STAFF REPORT

AGENDA ITEM: **Zoning Code Text Amendment, Final Plat and Planned Unit Development (PUD) Plans and Conditional Use Permit for Motor Vehicle Sales and Rental Facility**

City Engineer Review. The City Engineer prepared a final plat review memo (dated August 2, 2021) and a site plan/construction review memo (dated August 2, 2021) related to these requests. I have attached these memos for your reference. The following is a summary of his review comments:

EXISTING CONDITIONS &
REMOVALS PLAN

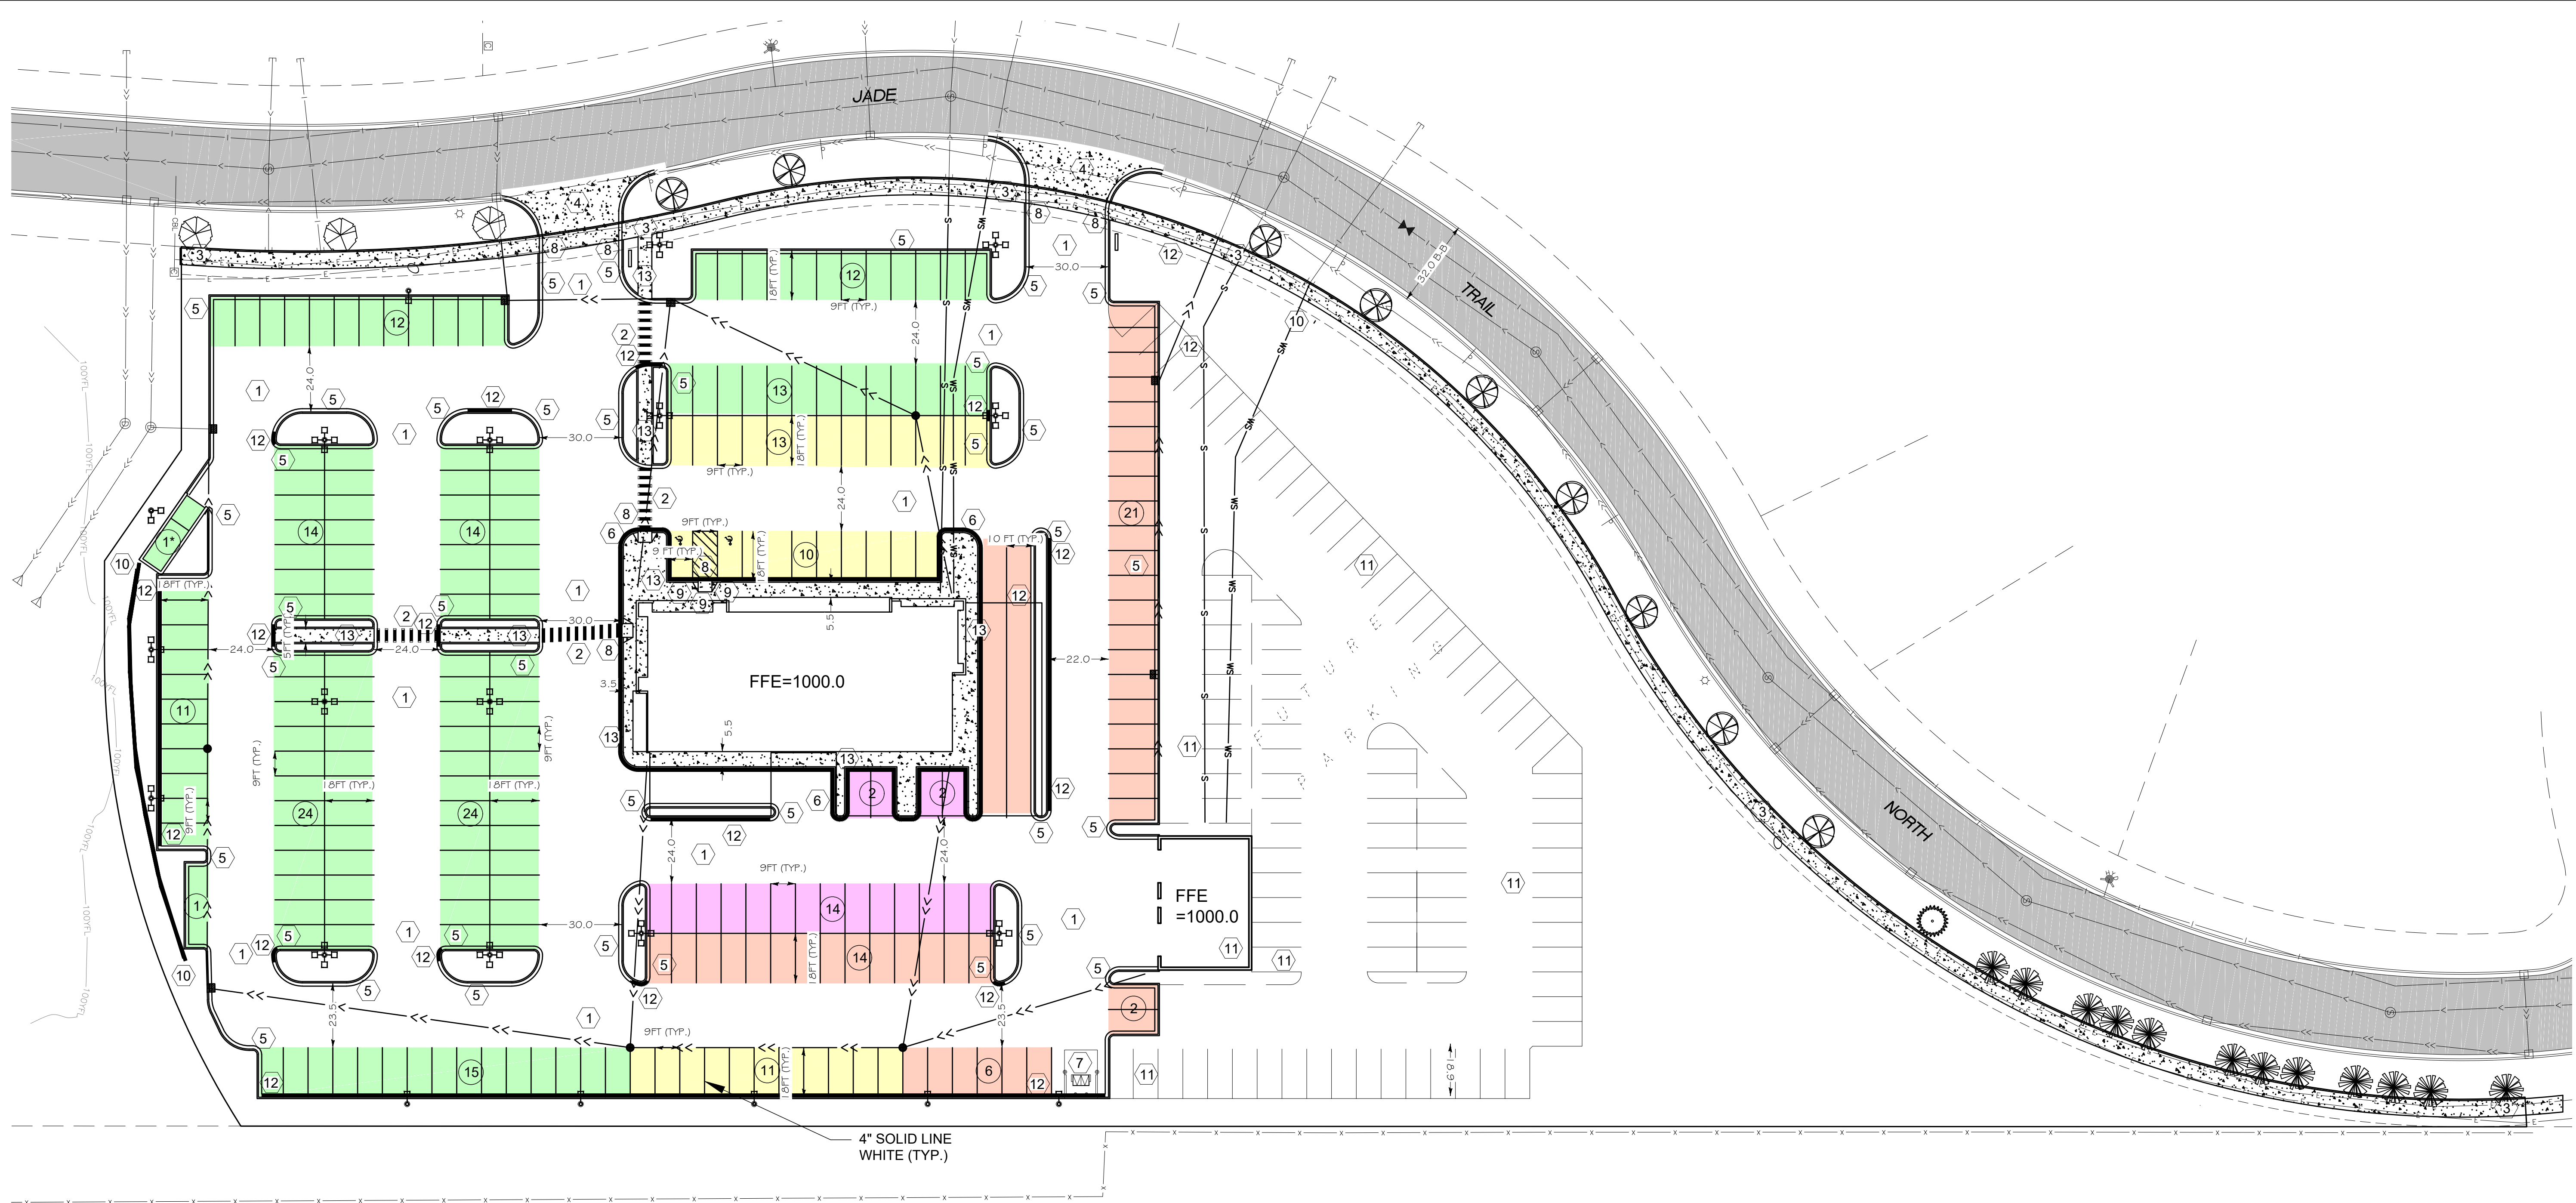
1. C2-C6. Add city standard details 105, 201, 313, 315, 405, and 606.
2. C7-C9/L100. Clarify if existing conditions include existing boulevard trees along Jade Trail. The landscape plans indicate boulevard trees as existing, while the existing conditions plan show no boulevard trees present. The Site plans indicate the boulevard trees as proposed.

SITE PLAN

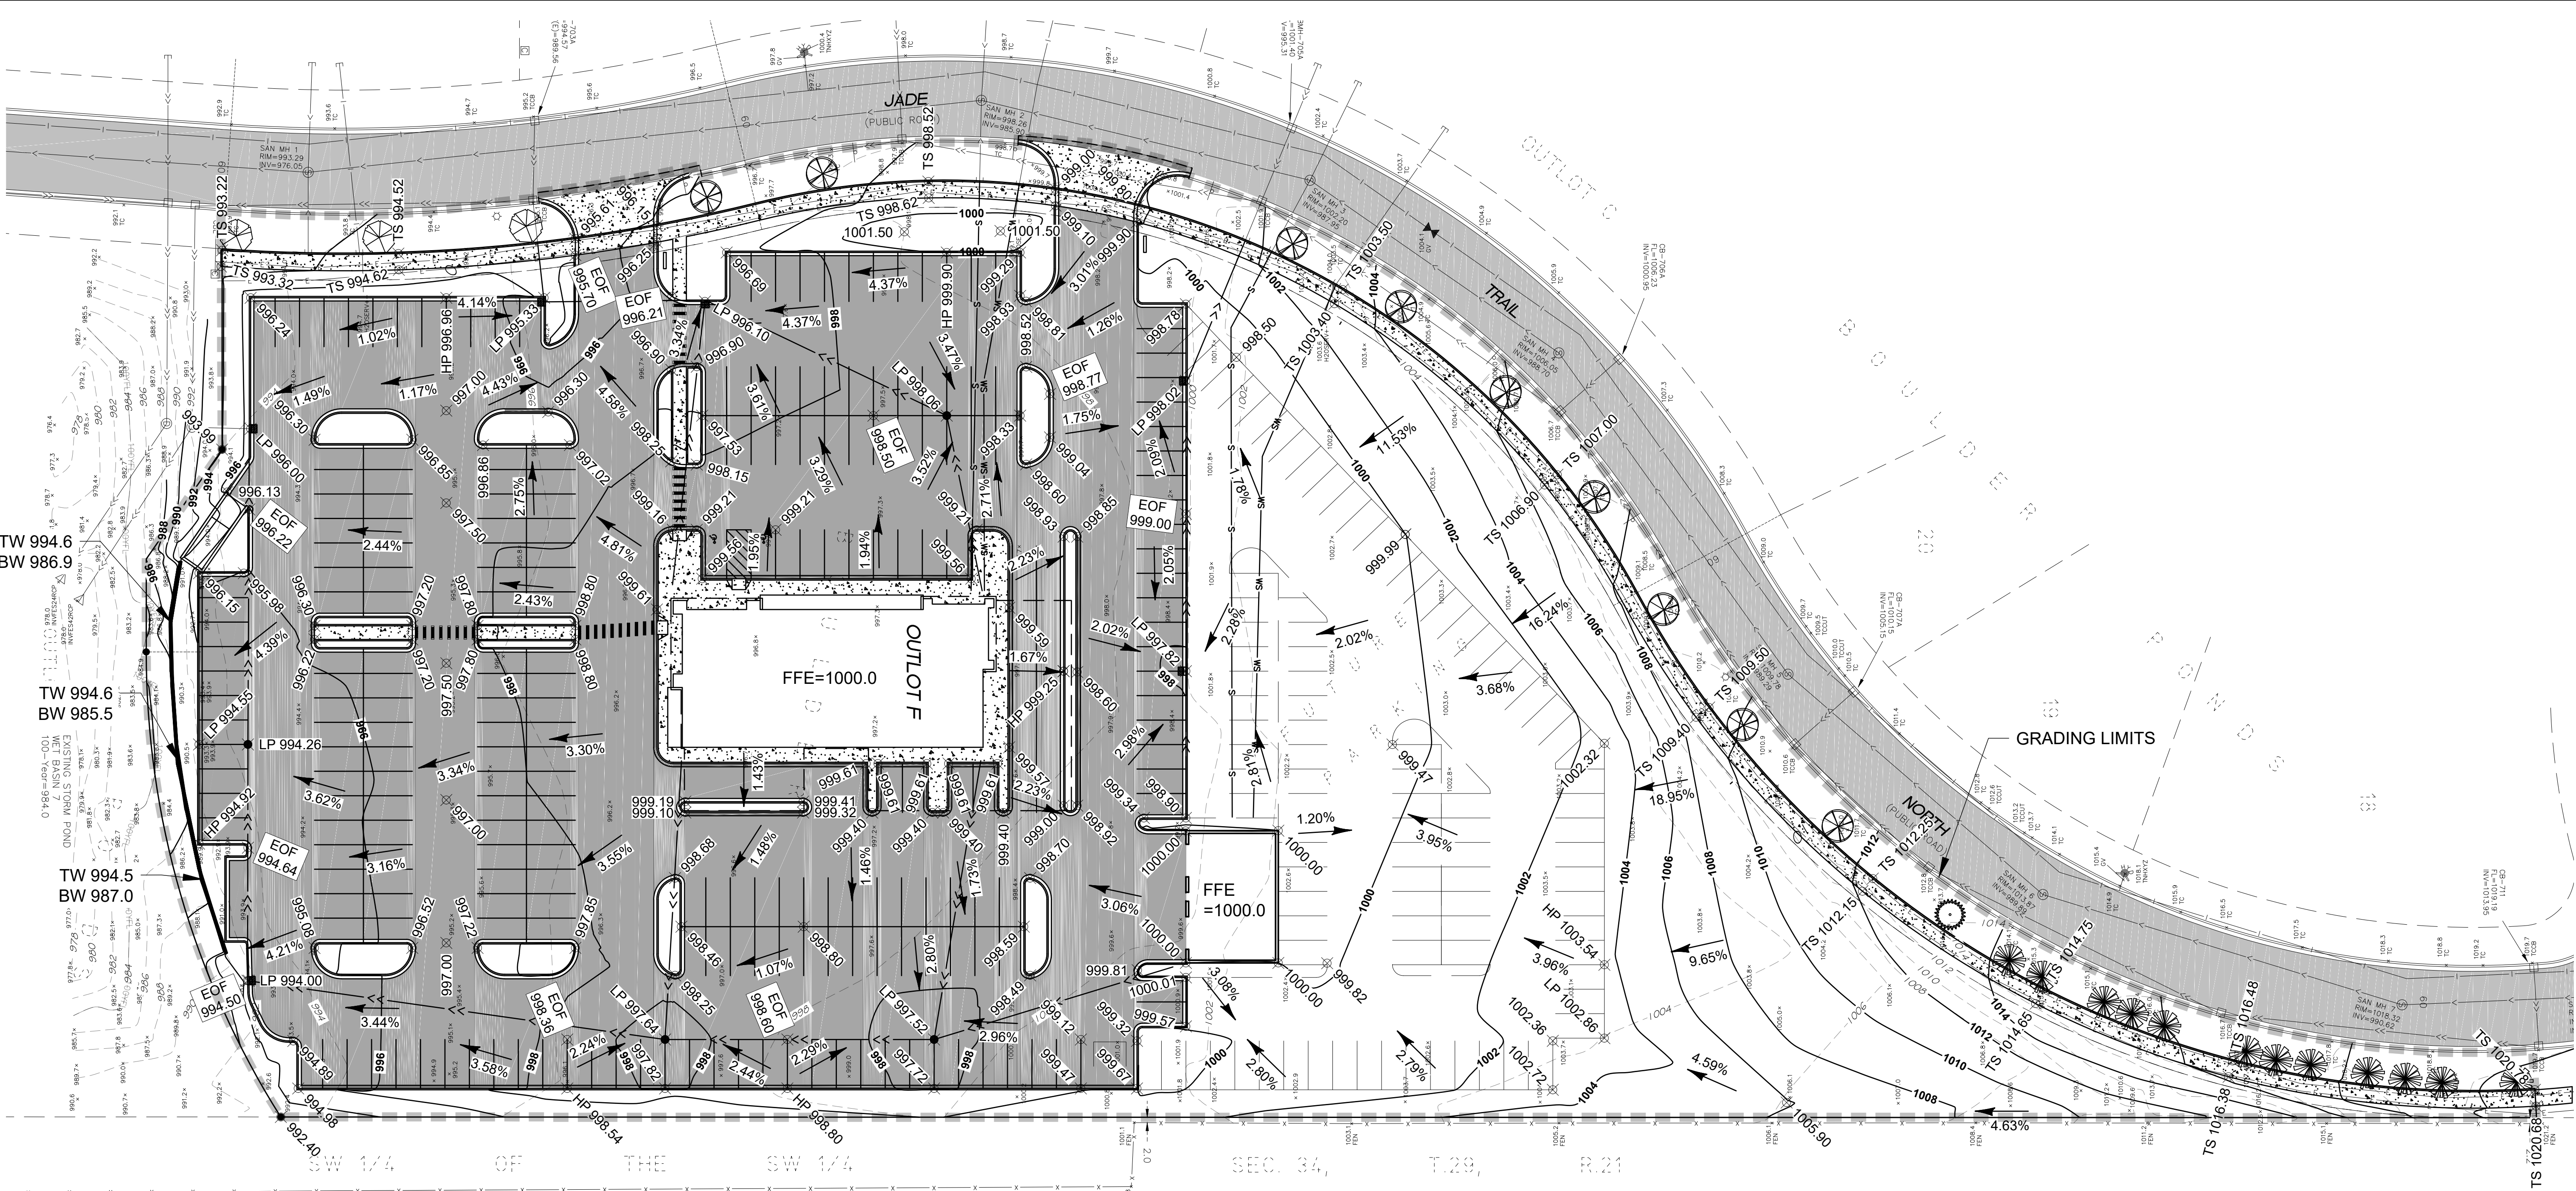
- The site parking area is designed with two concrete commercial driveway accesses to Jade Trail North, located about 180 feet apart. The two access locations do not appear to align with the driveway locations on the west side of Jade Trail for Growing Explorers or for the senior living center.
- The site plan and the landscape plan improvements must be clarified. The landscape plans indicate boulevard trees as existing, while the existing conditions plan show no boulevard trees present. The site plans indicate the boulevard trees as proposed.

7. C8. Add plan dimensions and labeling for existing street width, right-of-way width, and easement width. Label easement and property lines.
8. C8. Add city standard detail 805 to the Site Plan and revise plans as necessary to ensure the sidewalk, boulevard tree and boulevard grading is constructed per the city standard detail. Boulevard must be graded

GRADING & DRAINAGE PLAN

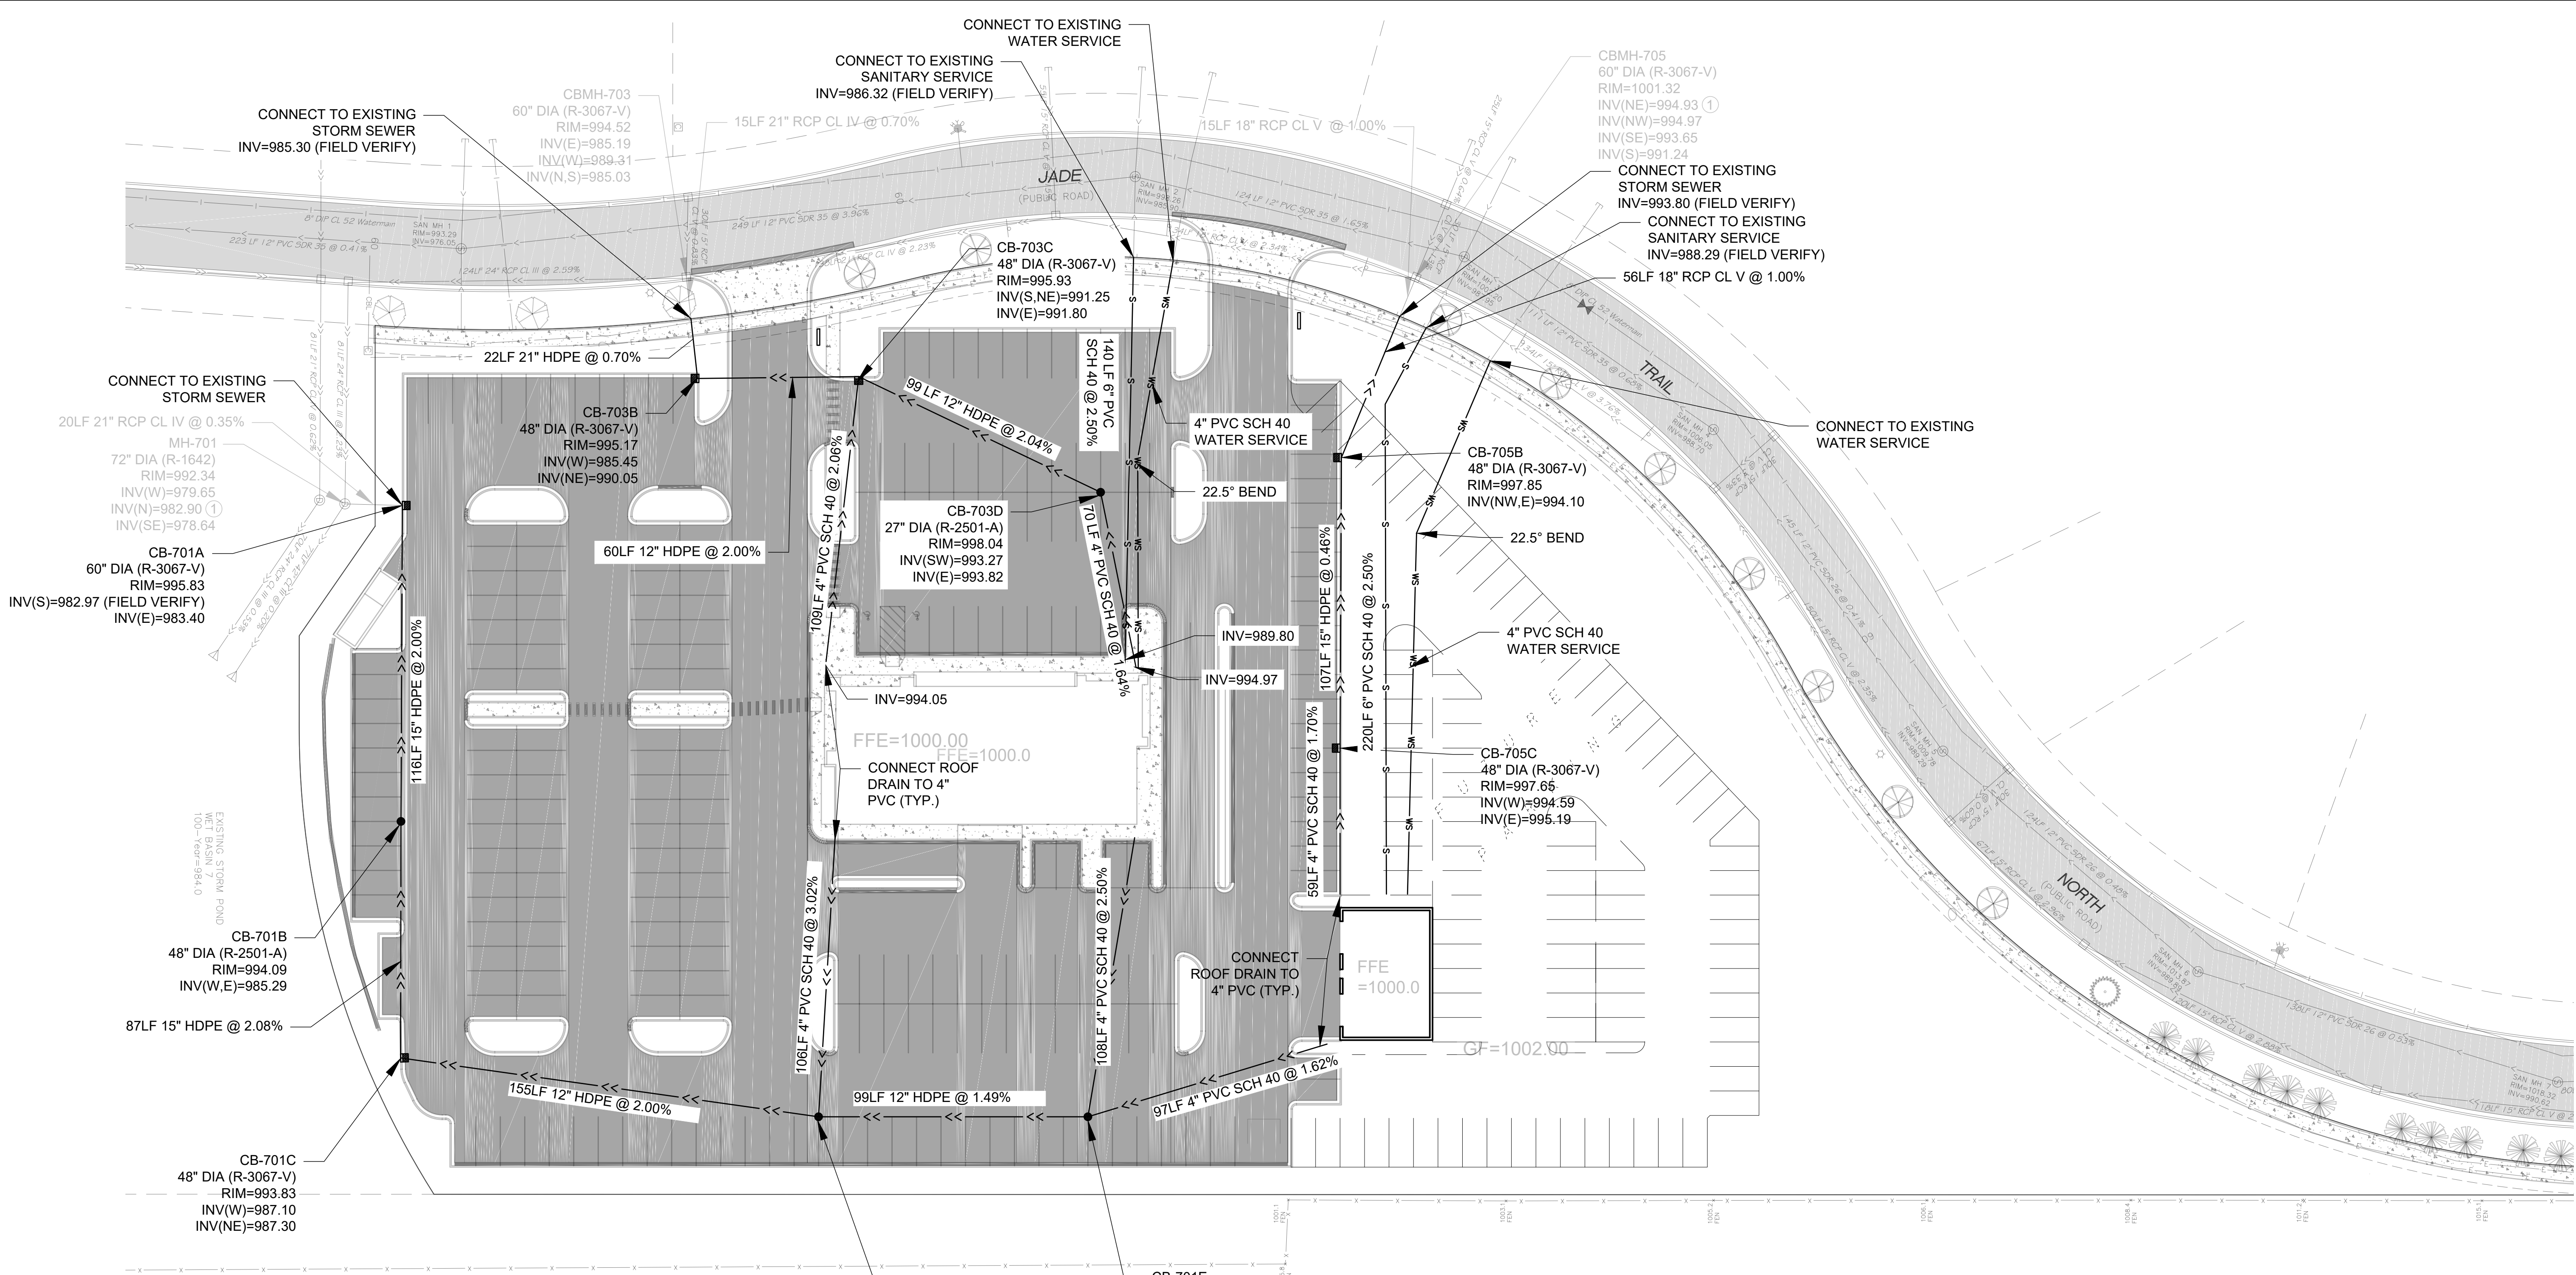
10. C9. Revise grading plan as necessary to grade the right-of-way and easement corridor along Jade Trail per city standard detail 805.
11. C9. Revise grading plans to ensure minimum 2% grade for all non-paved areas.

12. C9 and C11. Add the City standard plan notes to the grading and erosion control plans, City details 600A, 600B, 600C, and 600D. Remove these plan notes from the detail plan sheets.
